SUBJECT: SECOND REQUEST FOR ADDITIONAL INFORMATION REGARDING THE TRANSNUCLEAR NUHOMS® HD HORIZONTAL MODULAR STORAGE SYSTEM (TAC NO. L23738)

Docket No.: 72-1030
TAC No. L23738

REQUEST FOR ADDITIONAL INFORMATION
TRANSNUCLEAR, INC.
DOCKET NO. 72-1030

Figure 1

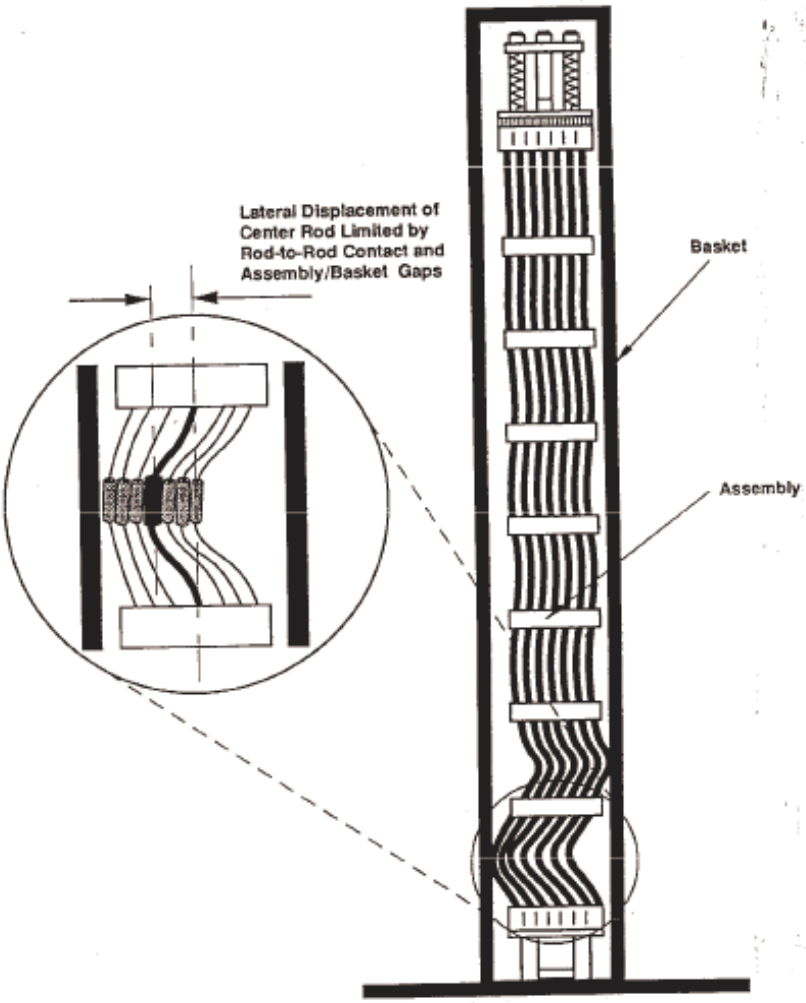
3-20 Provide an analysis demonstrating that fuel cladding integrity is maintained for the end drop event evaluated in SAR Section 3.5.3.2. Analysis assumptions should be justified based on the physical and behavioral characteristics of the fuel rods (cladding and fuel) in the assemblies. Cladding material properties should be consistent with high burnup fuel and include a thickness reduction due to oxidation.

In Section 3.5.3.2 "End Drop" TN performed a static nonlinear ANSYS analysis of a simply supported fuel rod "column" with initial curvature loaded by an incrementally increasing axial force. Cladding and fuels were assumed to act as a composite (i.e., "fused with each other"). The cladding was given elastic-plastic properties and a tensile failure strain of 1.6%, while the fuel was given only elastic properties and no failure strain. Because the fuel has an elastic modulus more than twice that of the cladding and a solid cross-section, almost all of the lateral load resisting capacity ("buckling" strength) of the fuel rod, in the applicant's analysis, is provided by the fuel, not the

cladding. The fuel is basically a coarse granular material with little tensile strength and therefore cannot be relied upon to resist tensile stress. This natural state of the fuel is not reflected in TN's analysis, which assumes that the fuel is a continuous solid with unlimited strength. The staff finds TN's analysis unacceptable.

The rod stress evaluation presented in the previous Section (A) due to 30g side drop is based on methodology described on LLNL report (Reference 1) and is based on modeling the fuel rod as a simply supported beam. In this methodology, the deflection of the rod is a function of the applied g-load and spacer grid span. In reality, as described in SANDIA report (Reference 2), as the g load increases due to the accident drop load, the deformation of the fuel rod is limited by the continuous support provided by the basket fuel compartments. The fuel compartment tube structure provides a rigid support structure to the fuel assembly. Figure III-6 from the referenced SANDIA report (reproduced here as Figure 1) shows that the maximum displacement of the center rod is limited by rod-to-rod contact and assembly/basket gaps during the accident end drop load. A similar situation can occur during the side drop accident load. Figure 2 illustrates the process by which the lateral deformation is limited to the sum of the gaps between individual rods in the assembly plus the thickness of the support grid.

Figure 2

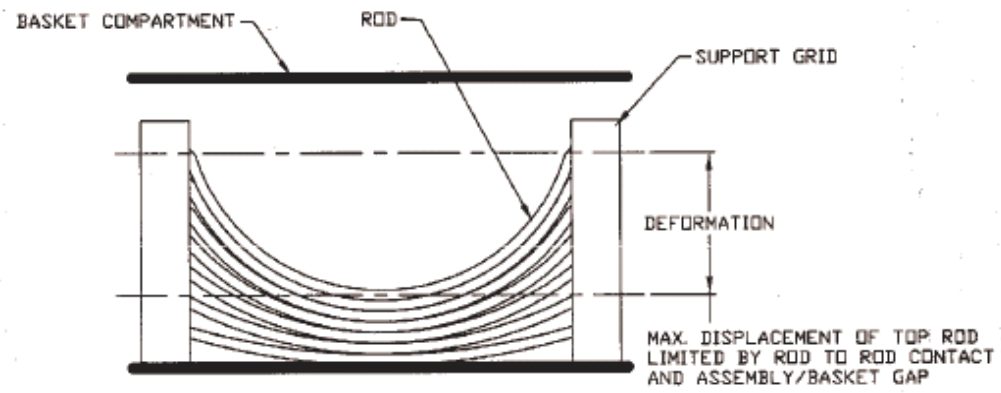
After discussions with TN, the staff received a second analysis in an email dated March 25, 2005, (this second analysis is documented below) that did not rely on composite behavior between the fuel and cladding, and addressed both Appendix 3.9.8, Section 3.9.8.11.1 and Section 3.5.3.1. Part A of the second analysis addressed Appendix 3.9.8 - a one foot side drop load of 30g. This analysis treated the fuel rod as a continuous beam over multiple supports and considered the bending resistance (MI) of only the cladding. The staff found this approach acceptable. Part B of the second analysis addressed Section 3.5.3.1 Table 3-12 - a side drop load of 75g. For this analysis TN abandoned the approach used in Part A and instead pursued a displacement limited approach. TN assumed the fuel rod was not a continuous beam over multiple supports (the model that had been used in Part A), but rather assumed that it was a simply supported beam spanning between adjacent grid spacers - the most flexible condition possible - and imposed a displacement limit approximately equal to the maximum total gap between adjacent fuel rods plus the gap between the assembly and basket. Because of the simply supported beam assumption, the staff found the approach in Part B to be non conservative and inconsistent with actual fuel rod behavior during a side drop event and, therefore, unacceptable.

The lateral restraint, shown in Figure 2, is based on all fuel rods having the same deformation pattern, with their lateral deformation constrained by the assembly and basket. This deformation is the maximum deformation possible regardless the applied g load. This assumption is justified since the basket structural stiffness is very large relative to the structural stiffness of the fuel assemblies and

δ = [(rod pitch-rod OD) - (no. of rods in a row -1)] + {assembly width - [rod pitch x (no. of rods in a row -1)] – rod OD}/2

Maximum deformation:
δ = [(0.563" – 0.4193") - (15-1)] + {8.426" - [0.563" x (15-1)] – 0.4193}/2
= 2.0118" + 0.06235"
= 2.07415"
